TECHNICAL INFORMATION

RANGE	MODEL	VERSION	T.I. - NO
HOT & COLD	**ASTRO-KIKKO-OBLO'**	**ALL VERSIONS**	**03/2004**

SERIAL NUMBERS AFFECTED	ISSUED BY
	STC.CO
SUBJECT	ISSUED FOR
NEW FRICTIONED CAM FOR NOZZLE ARM MOTOR	**INFORMATION**

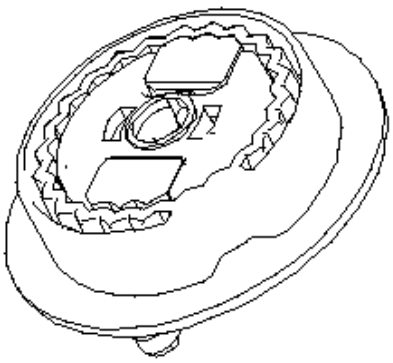
The nozzle arm motor on the above-named machines has been equipped with a new frictioned cam (part code **251519**), replacing the previous one (part code **0V3692**).
The cam is fitted with a clutch, in order to prevent the motor being damaged by mechanical forces.

The new clutch releases the nozzle motor when the values of traction/compression are too high.
These high values could compromise the motor's reliability.
